Invitation for Bid #10-1766DC

Juvenile Process Center Building Modifications

ADDENDUM #3

JAMB RETROFIT DETAIL SCALE: $1 \frac{1}{2} = 1'-0''$

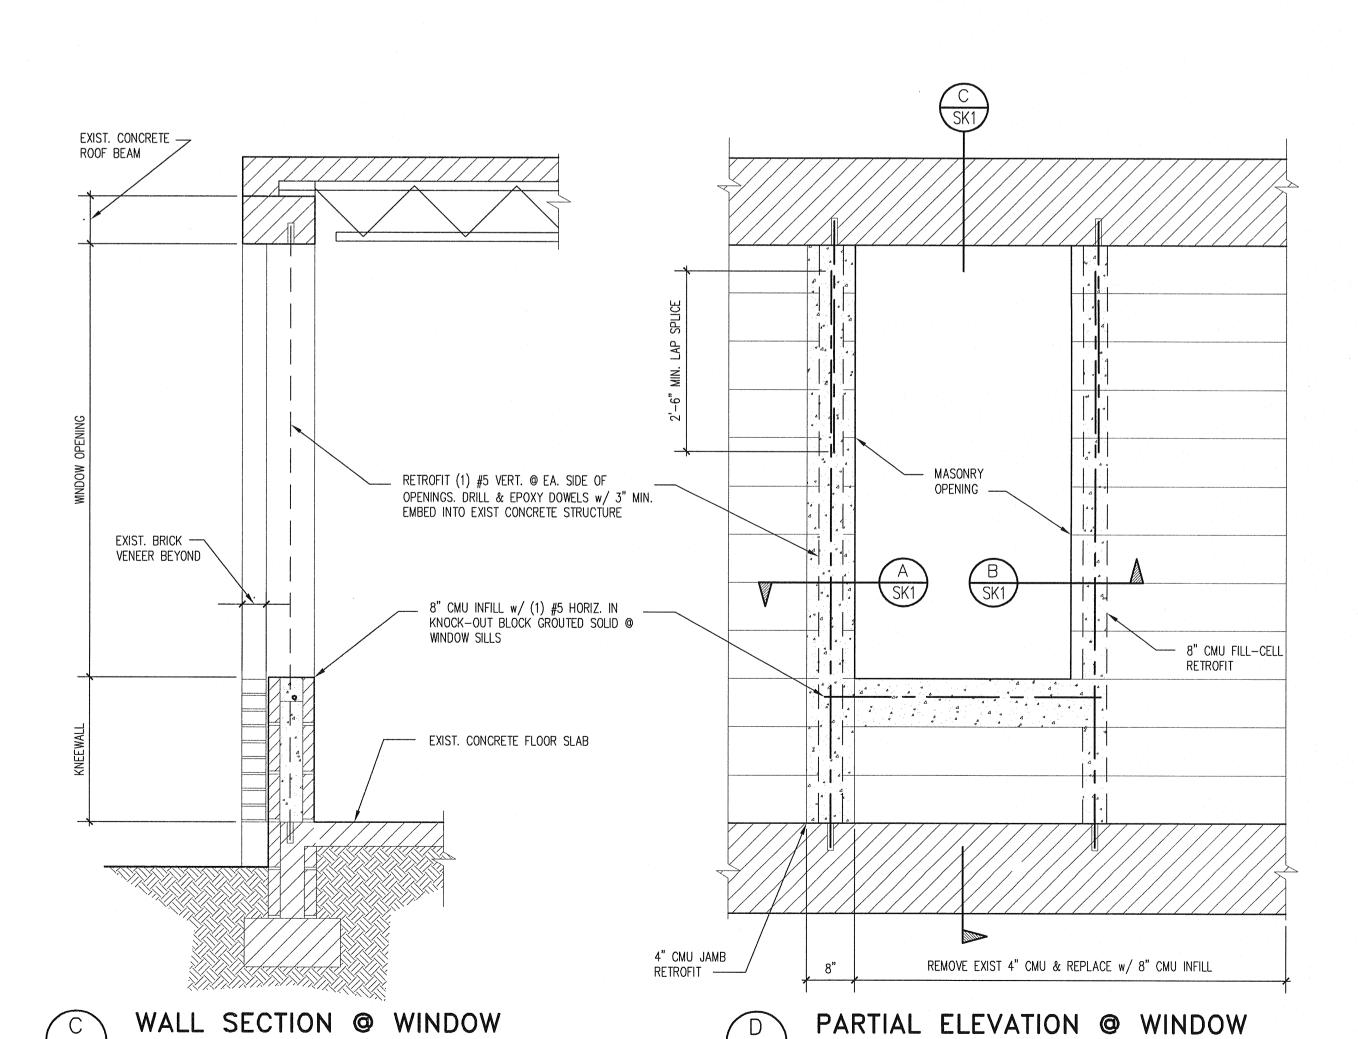
The drawings show the existing walls to be 8" block cmu, however most if not all of the perimeter (exterior) walls are actually 4" partition block with 4" brick at the exterior. There is no standard engineering to affix doors and windows to this condition and to comply with wind load requirements. Will the drawings be revised to show a detail for the door/window installation?

BMK Response: See revised architectural plans and added structural sheet

E-2

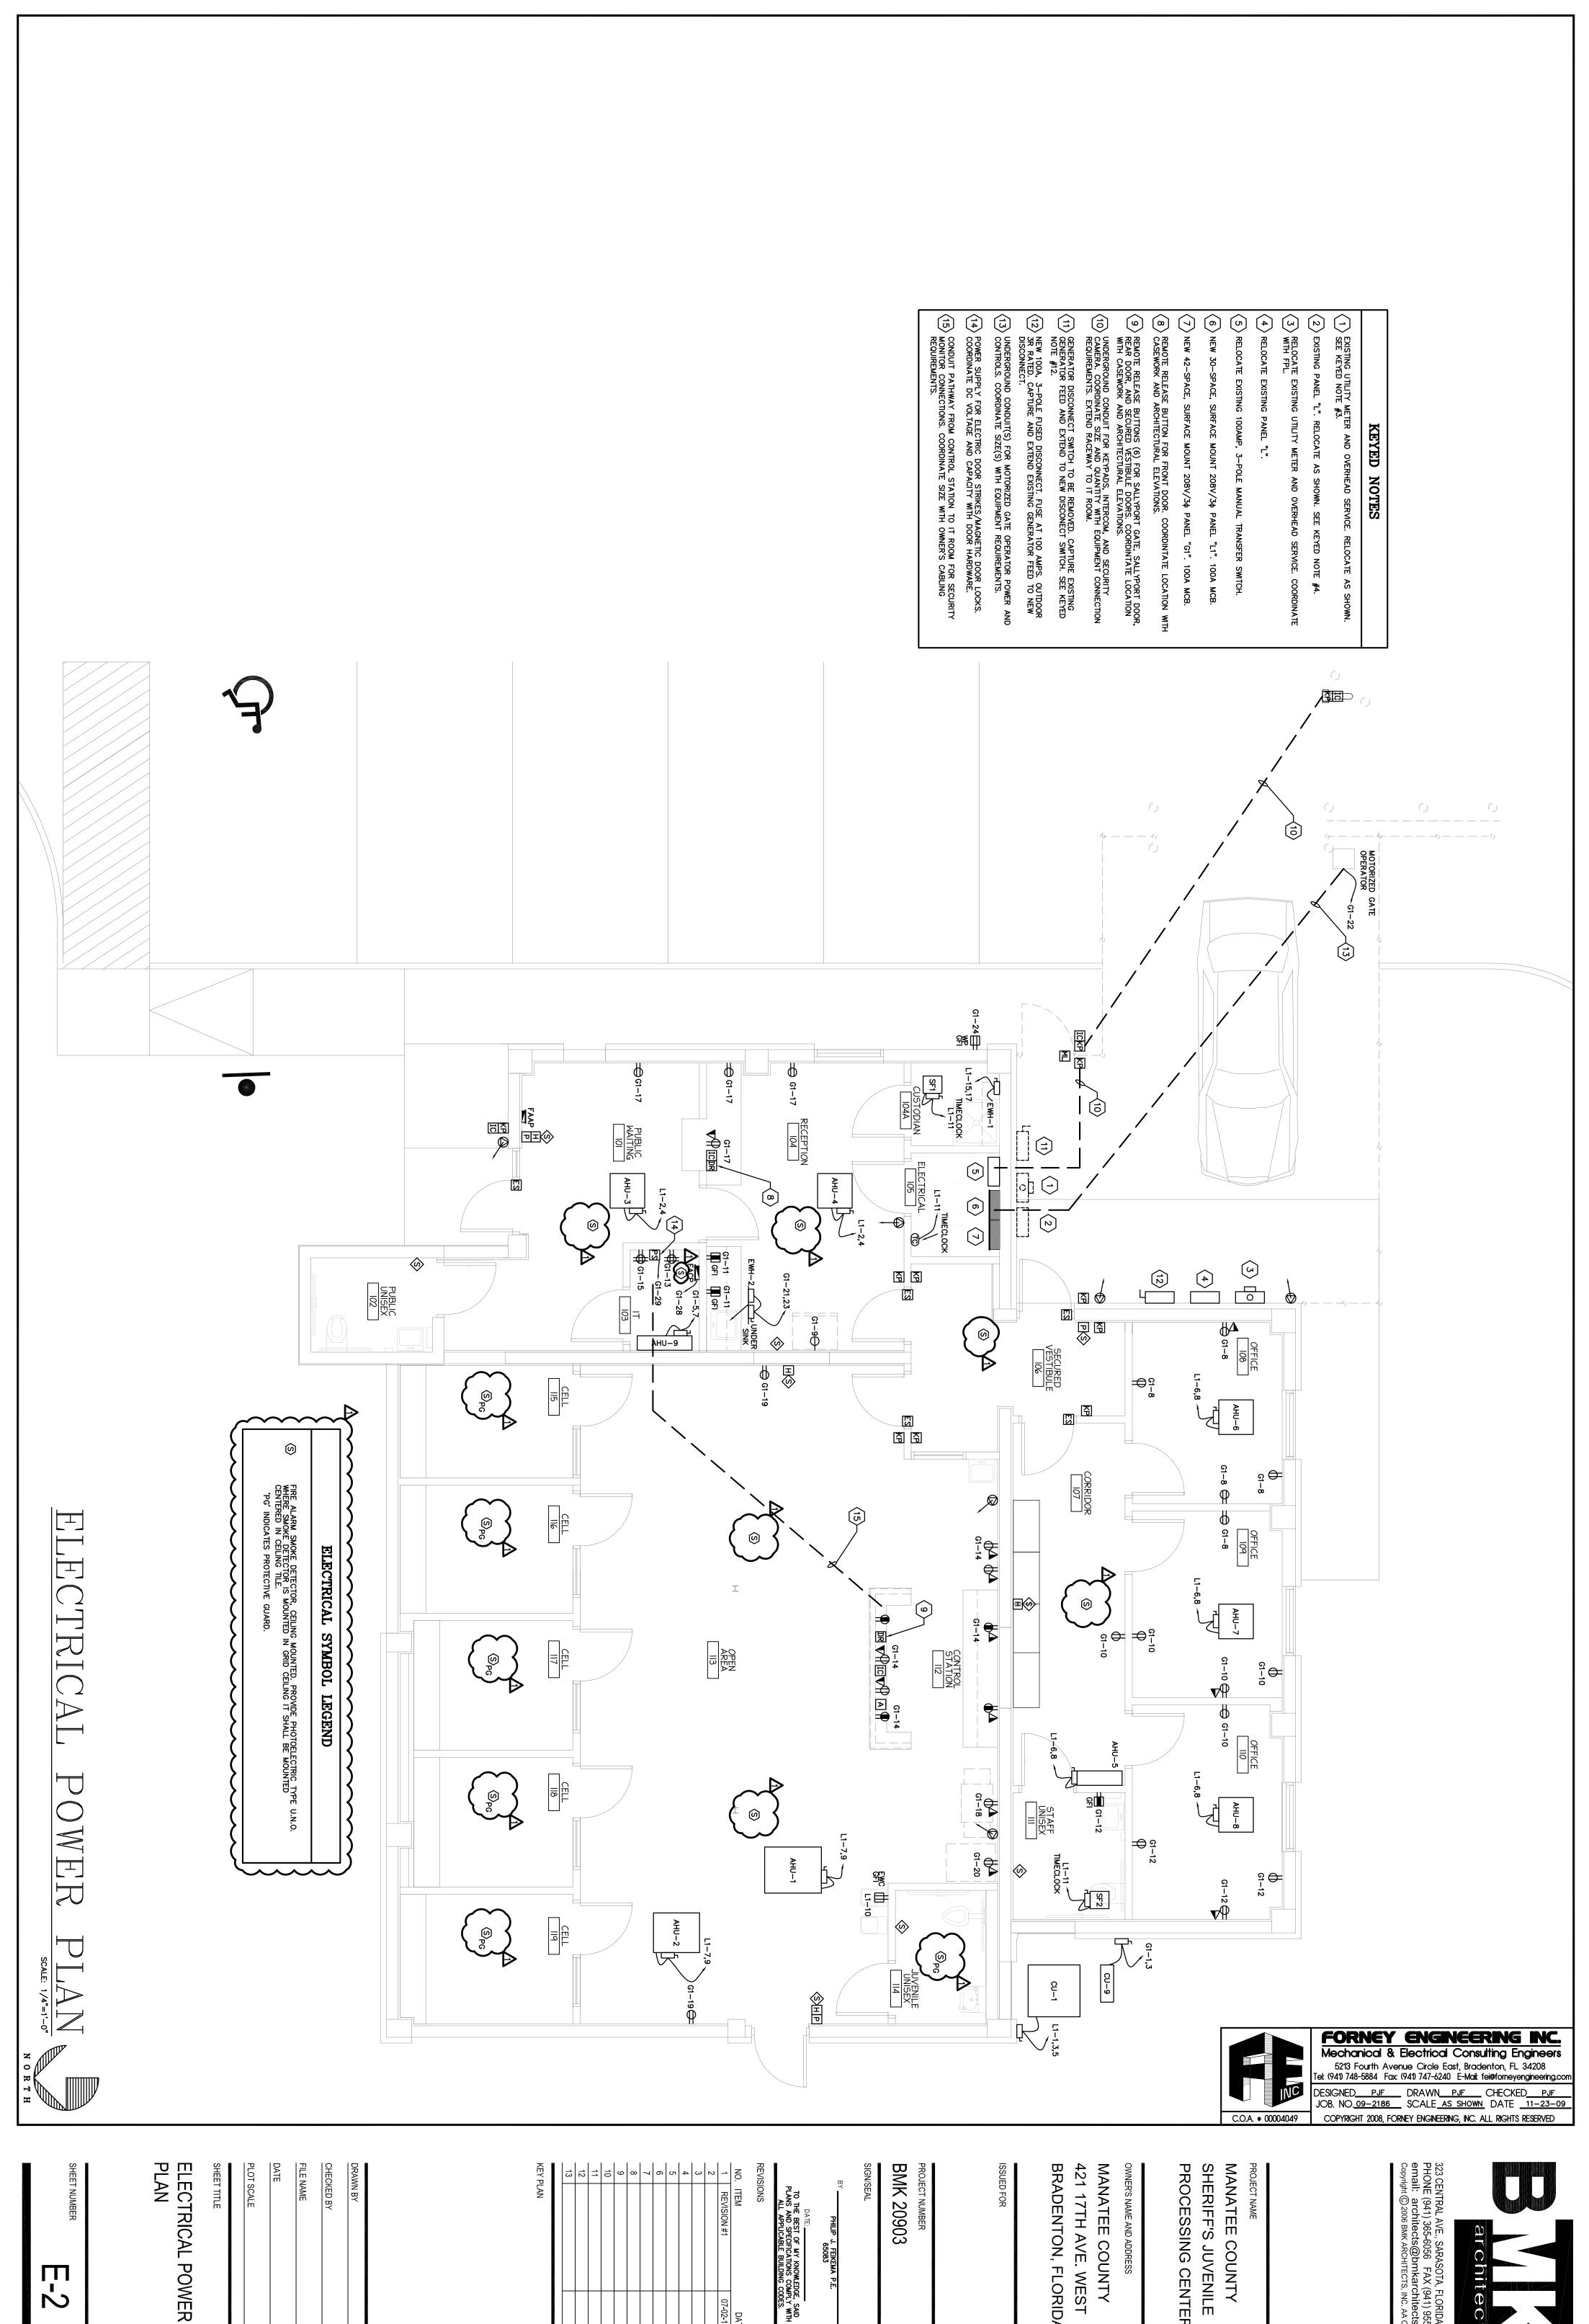
- a. The 2' x 4' light fixtures (2) shown in room 107 (Corridor) shall be Type "B". The fixture type was omitted on the plans.
- b. The 2' x 4' light fixture shown in Room 111 (Staff Restroom) shall be Type "B". The fixture type was omitted on the plans.
- c. The Mark Architectural Lighting NOL series (provided by Envision Lighting) with 1.75" mounting depth is an acceptable substitute for the Type "B" fixture Corelite R1 series specified on the plans.
- Replace Sheet E-2 with Revision #1 dated 07-02-10 (PDF attached).
